CONDITION 12

PP/02/01324

Lots Road Power Station And Chelsea Creek

SUBMISSION OF DETAILS OF A SCHEME FOR THE TREATMENT OF CHELSEA CREEK PURSUANT TO CONDITION 12 OF PLANNING PERMISSION PP/02/01324 GRANTED BY THE SECRETARY OF STATE ON 30 JANUARY 2006.

Direct e-mail anna.scott@environment-agency.gov.uk

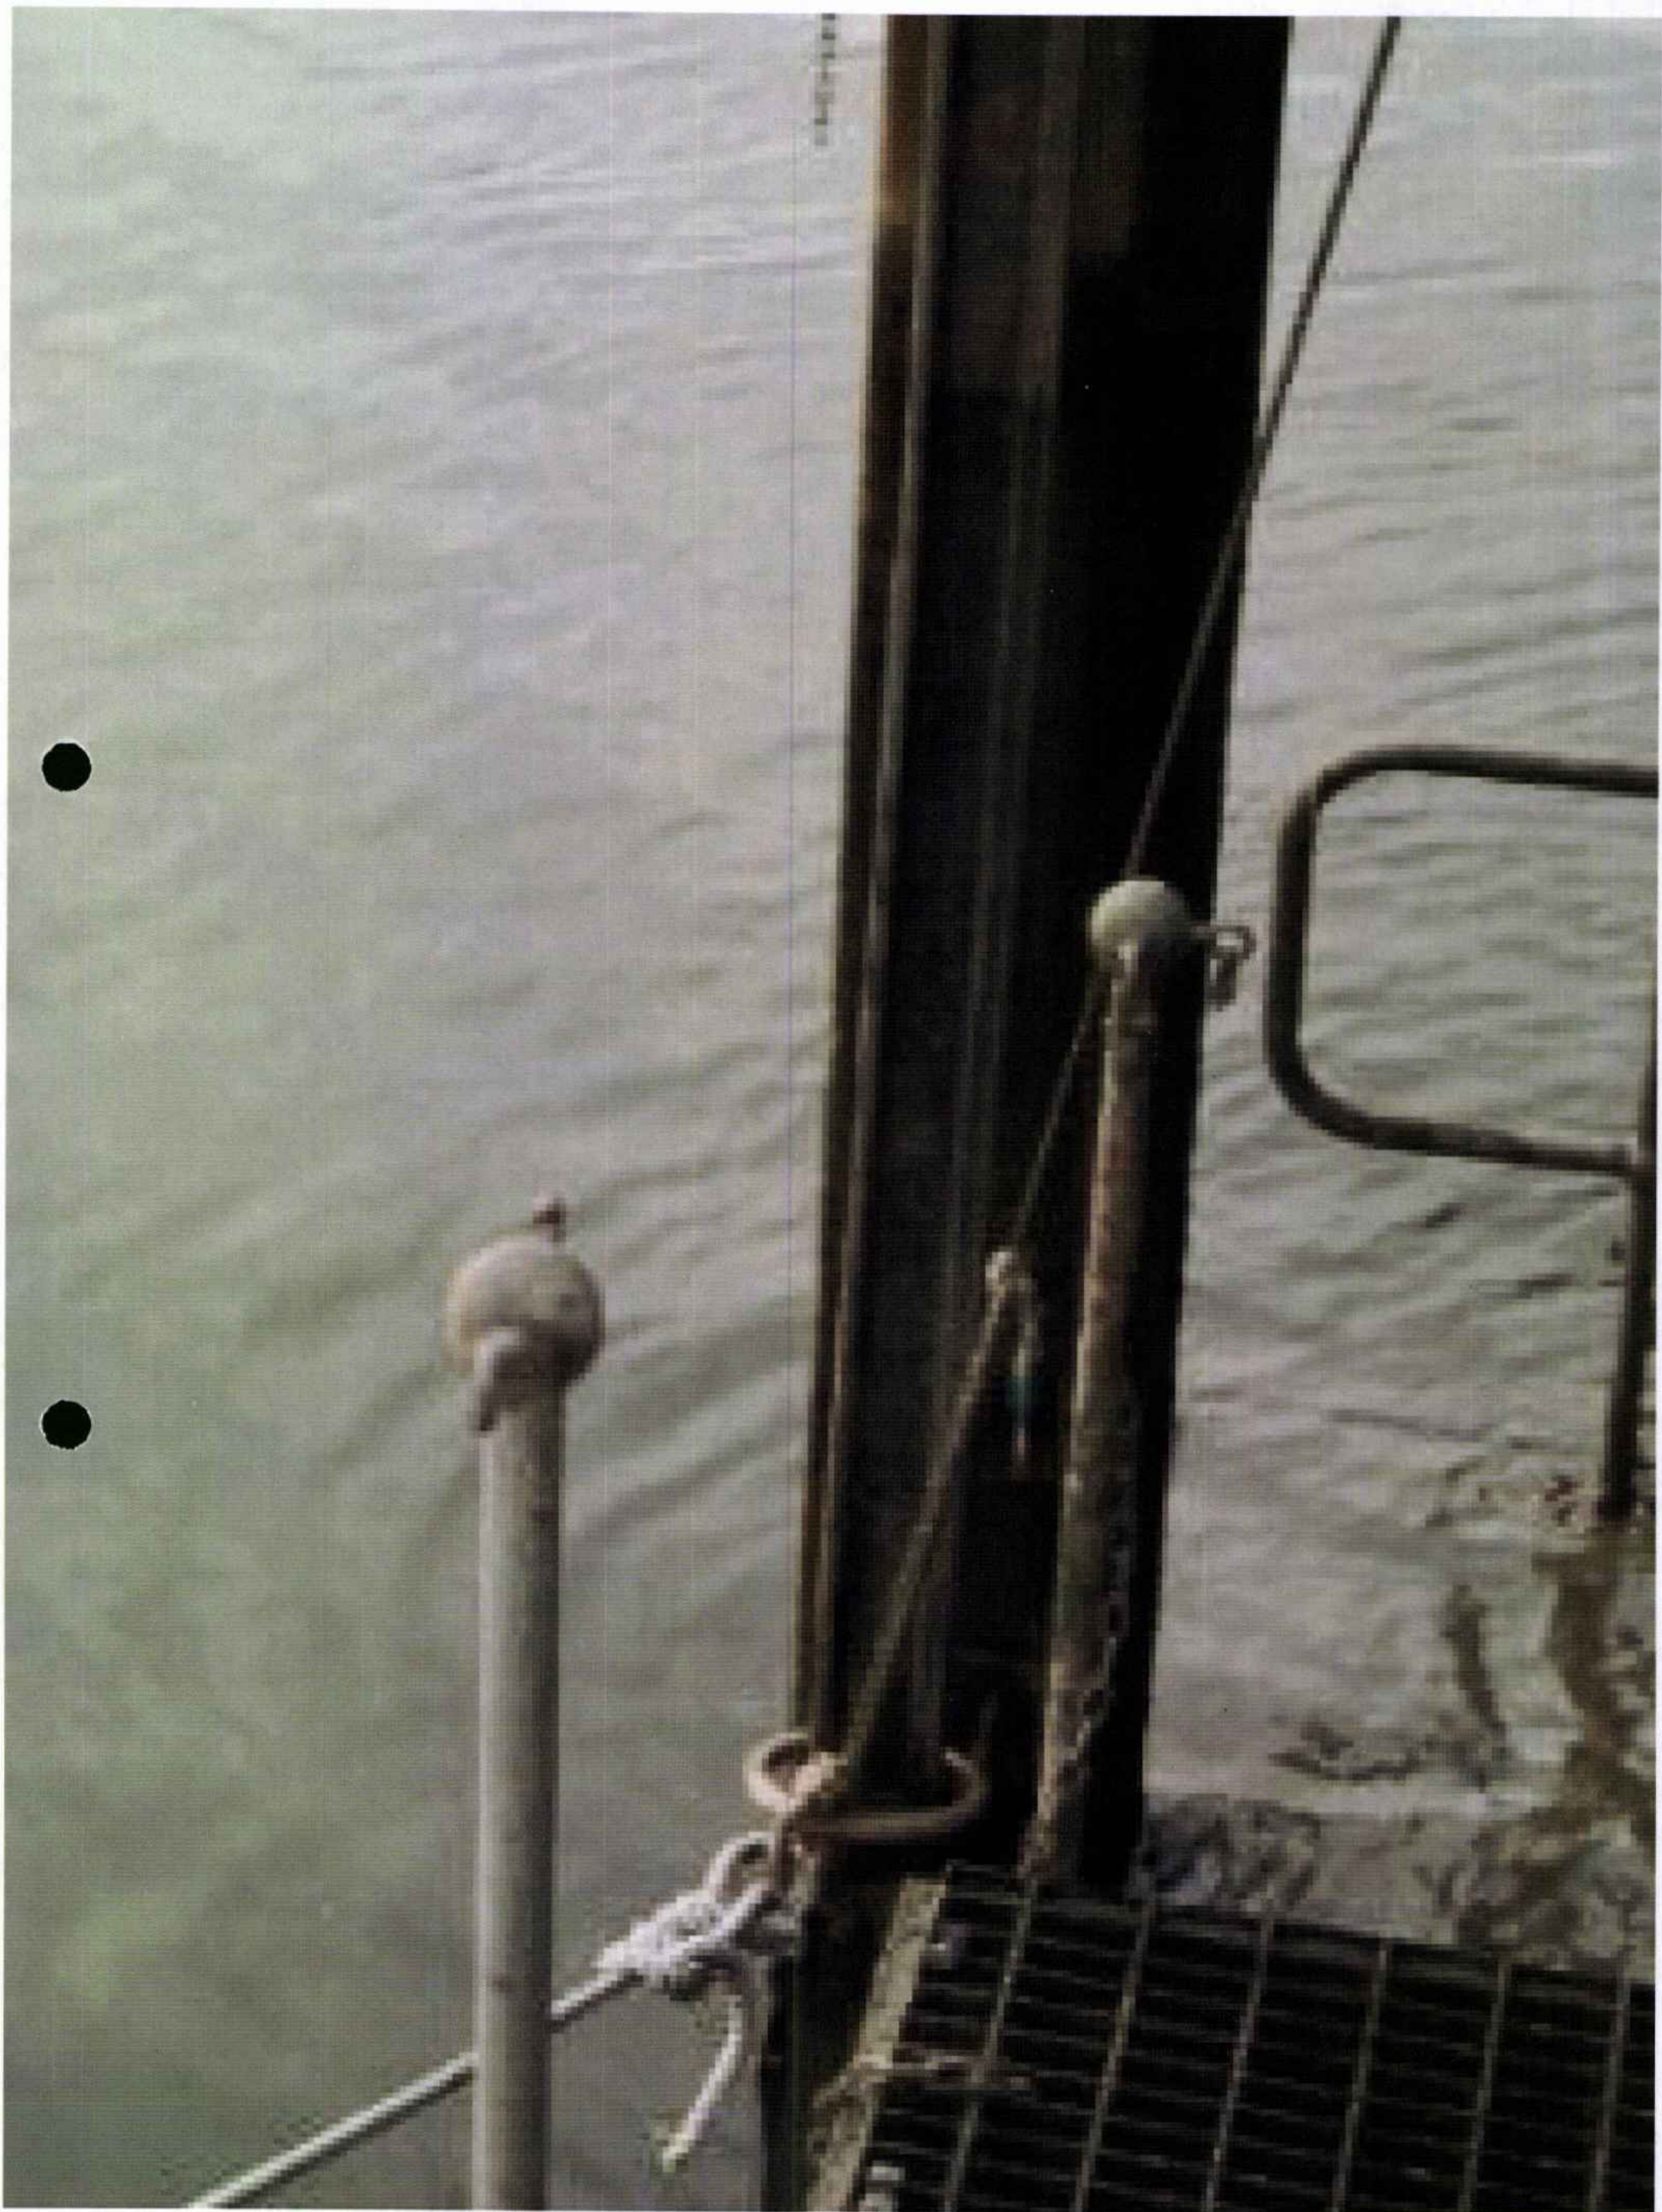
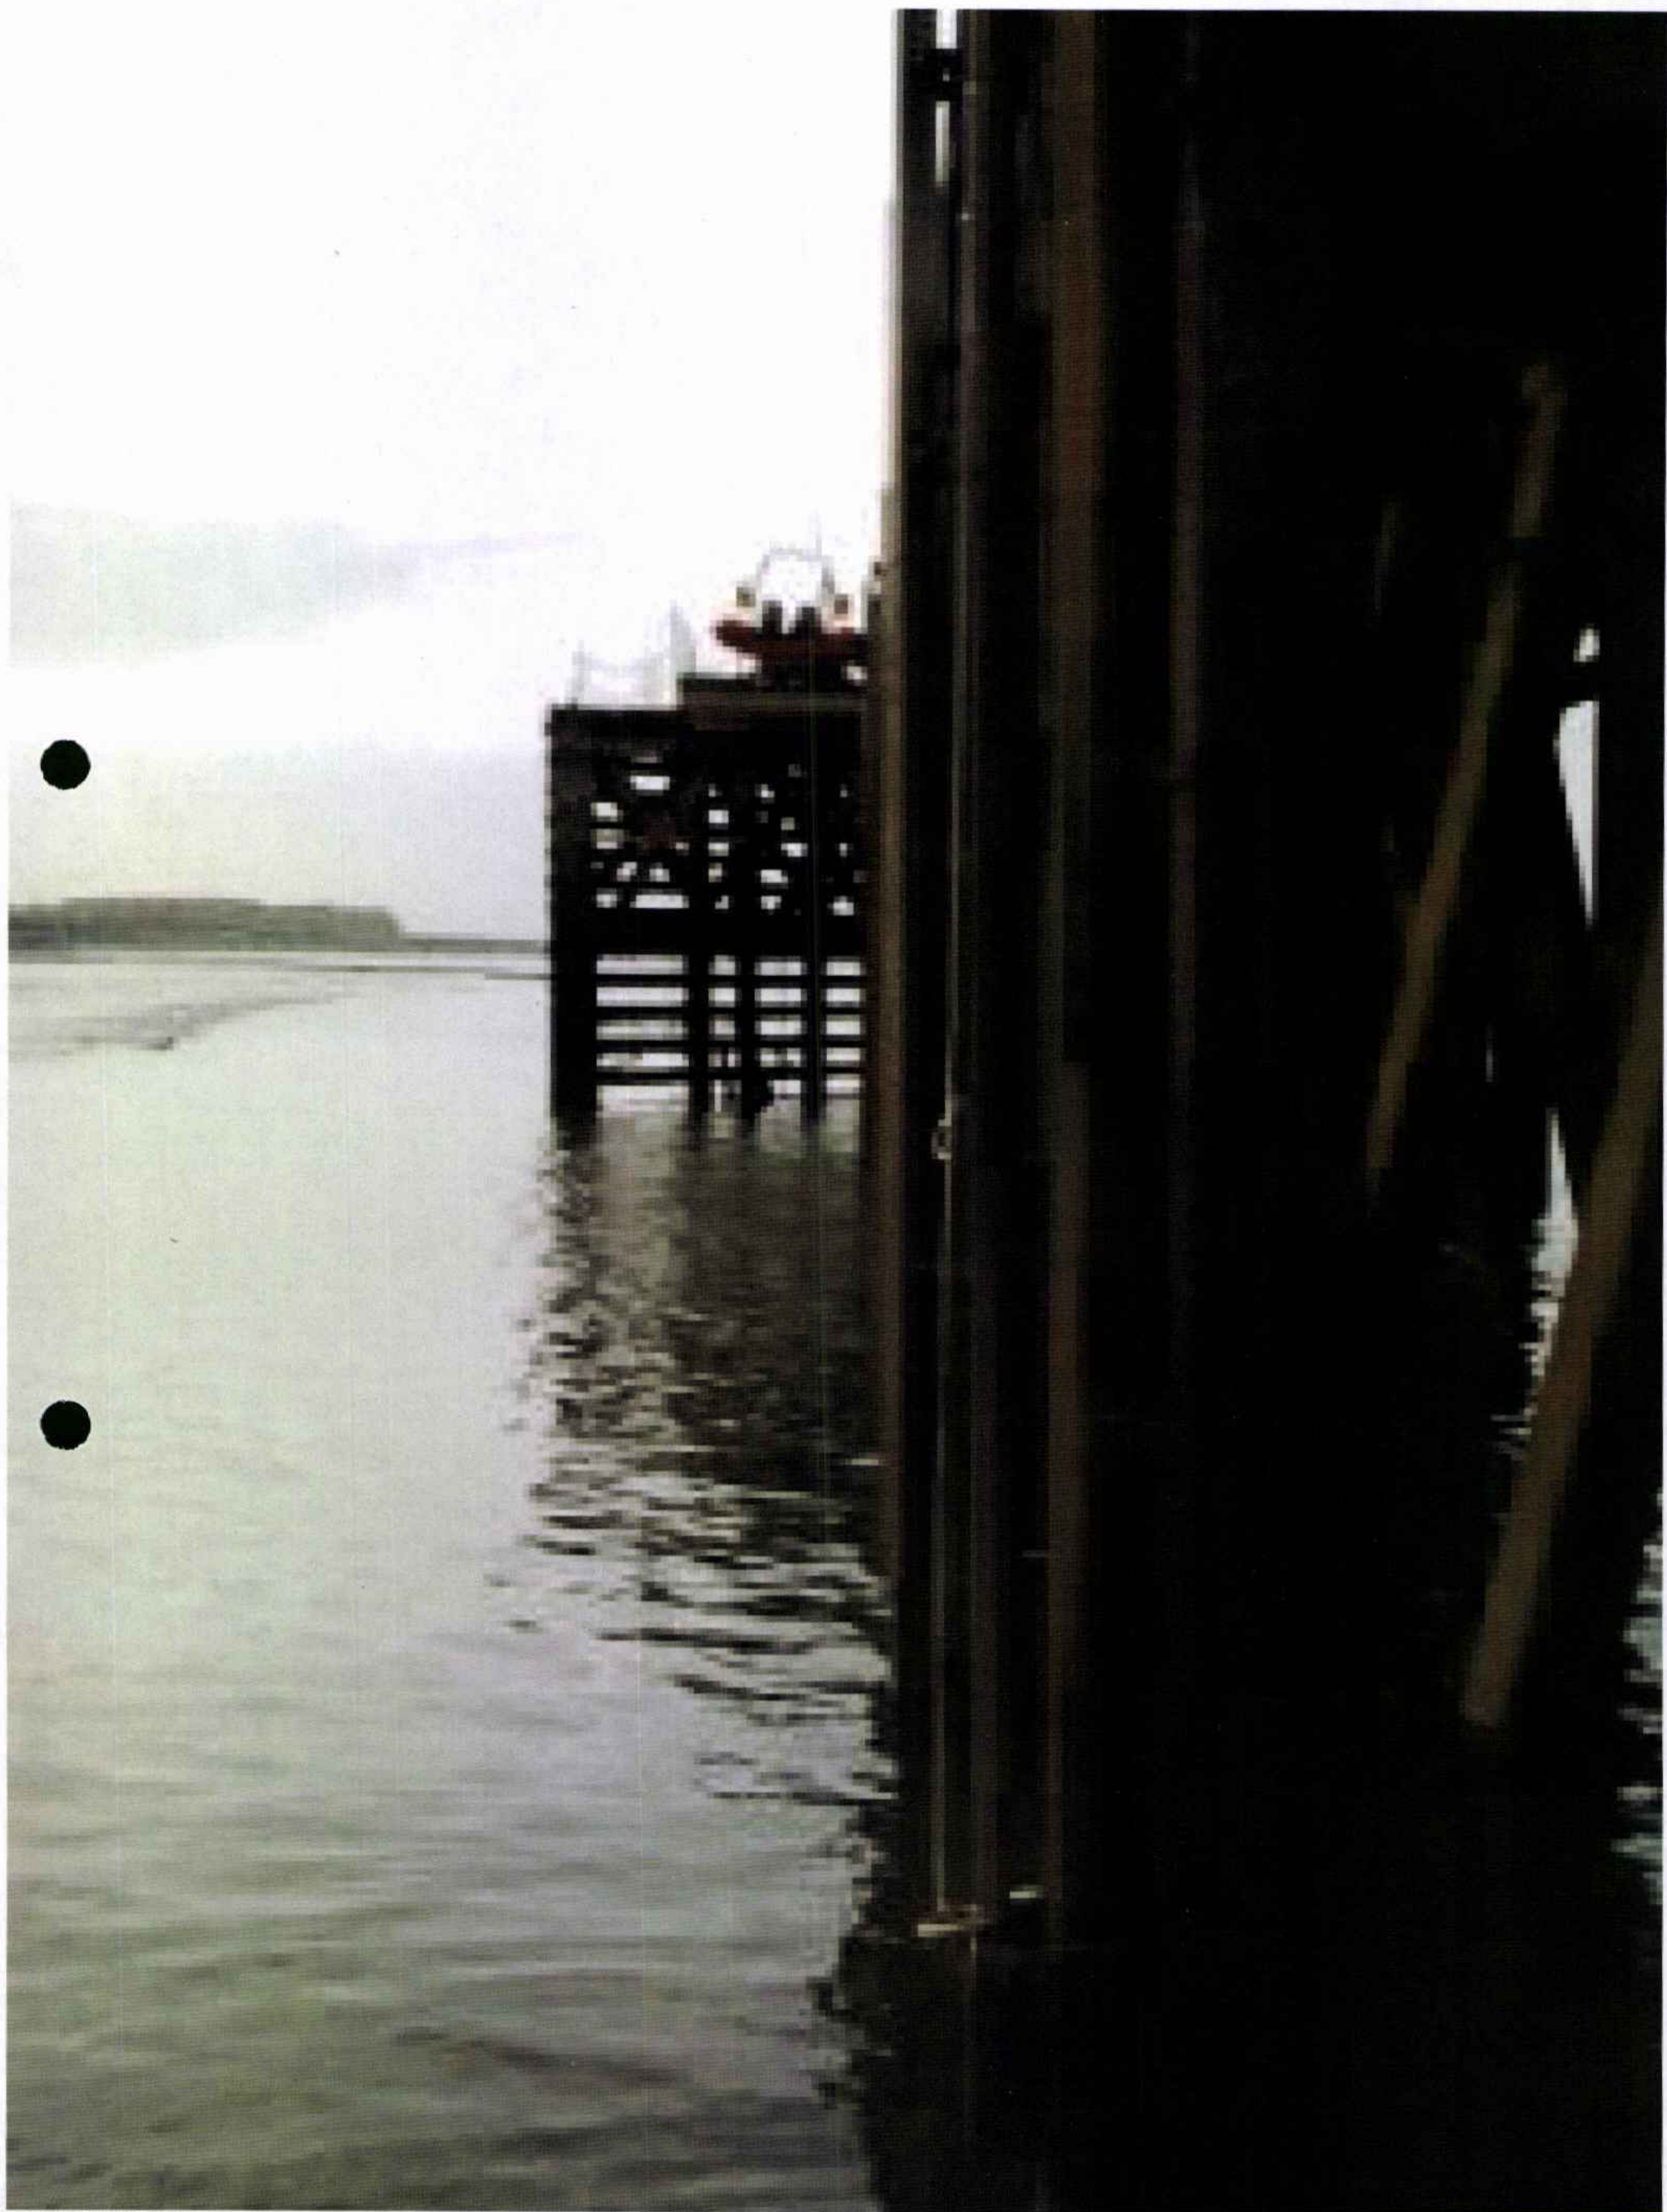
We request that drawings are submitted to show a boating landing pontoon to be accommodated within a gap in the terraces adjacent to the crescent shaped park. We are happy to advise on the design of the pontoon.

We recommend that either a rise and fall pontoon or provision for an access ladder with vertical fenders and vertical risers with rings. These are traditional method used for tidal waters. Please refer to photos attached to this letter.
